CENTERVILLE WORK SESSION AGENDA

Short Title: Work Session re Cemetery west slope analysis

Citizen Input for the Centerville City Cemetery Expansion

Tanner Comments on Cemetery Expansion

1983 Dirt and Debris Dumped in Cemetery:

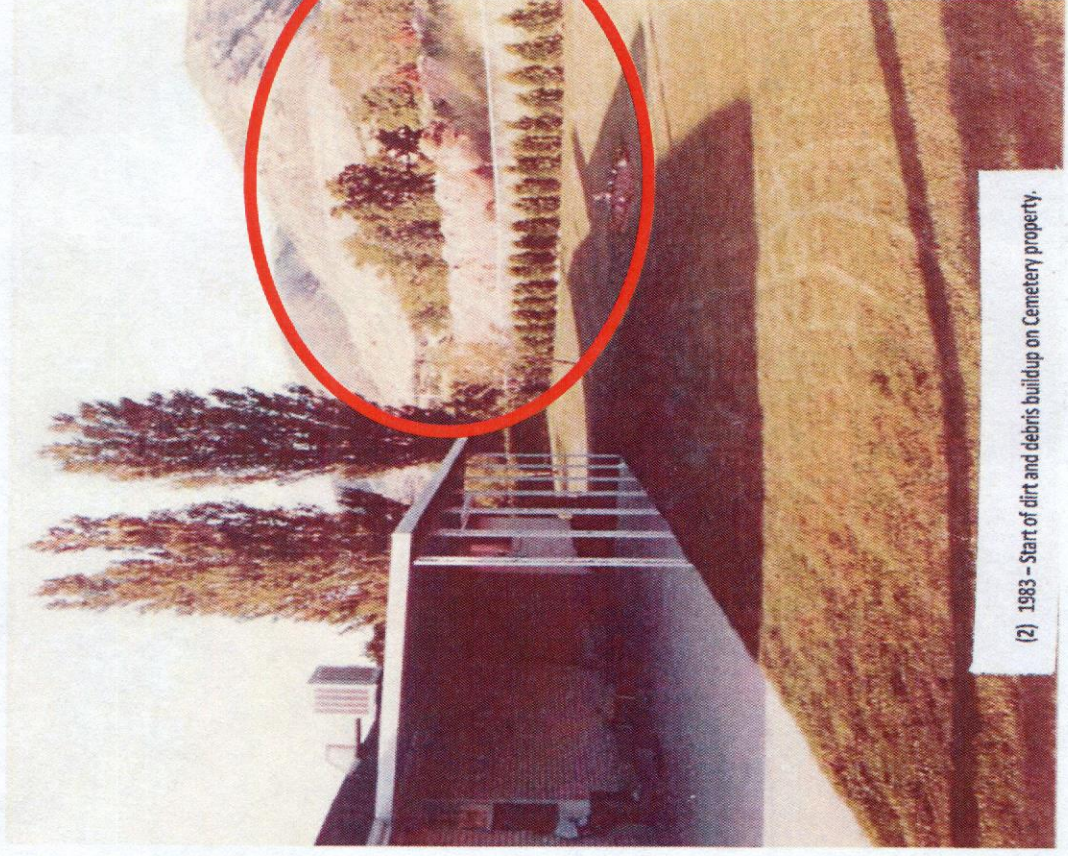
(2) 1983 - Start of dirt and debris buildup on Cemetery property.

1983 Ford Family Built a Concrete Block Wall: Prevent Future Flooding from the Cemetery

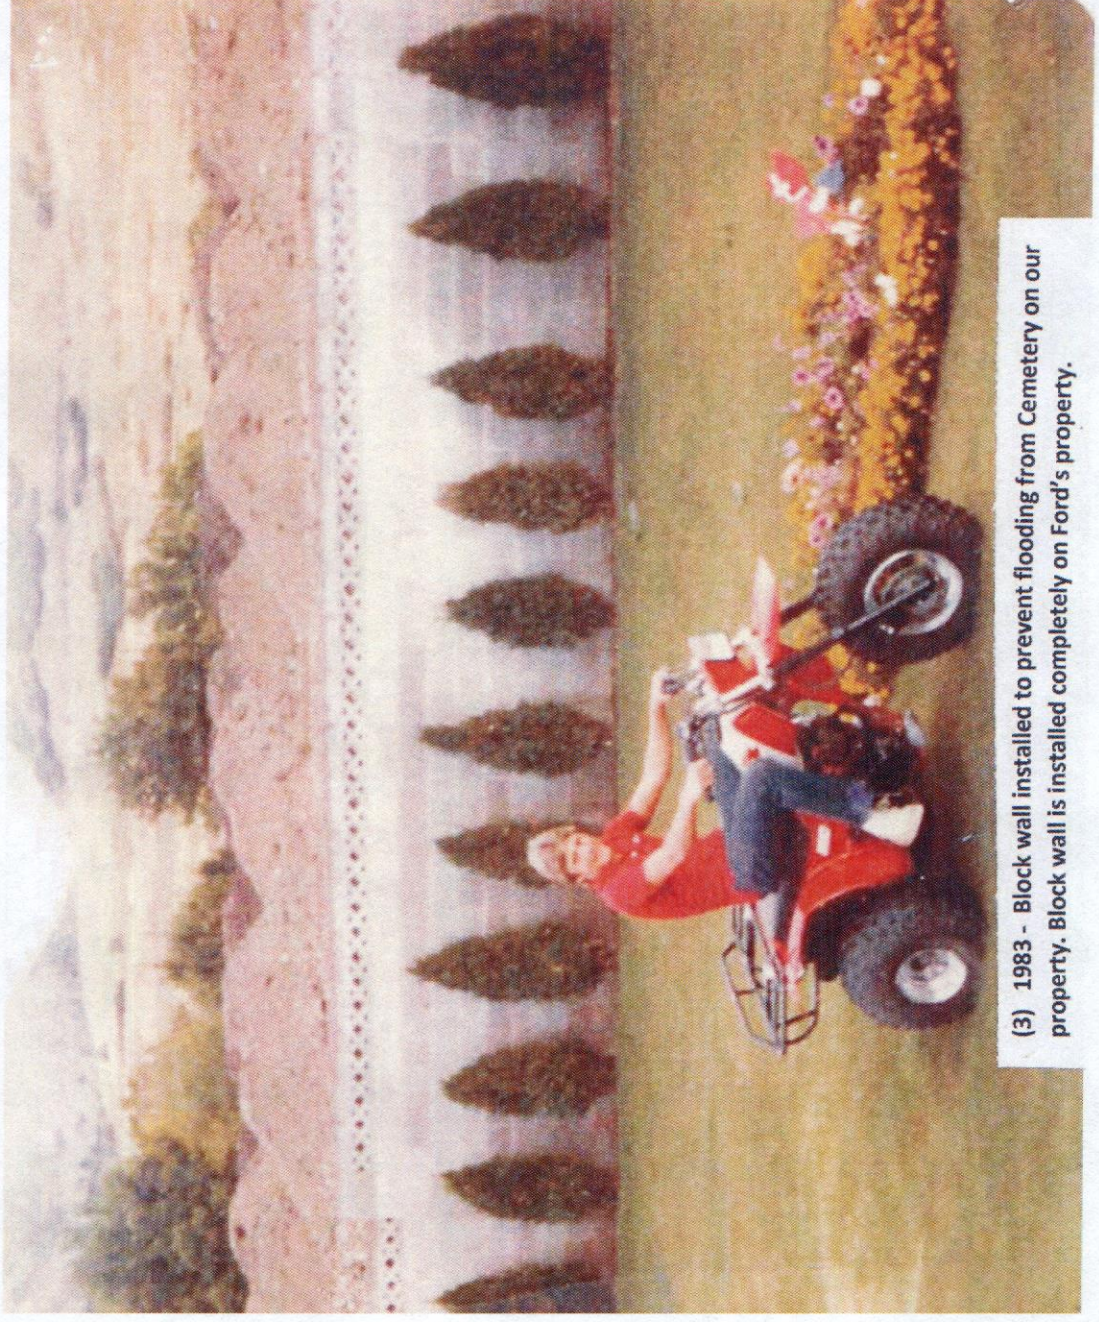
(3) 1983 - Block wall installed to prevent flooding from Cemetery on our property. Block wall is installed completely on Ford's property.
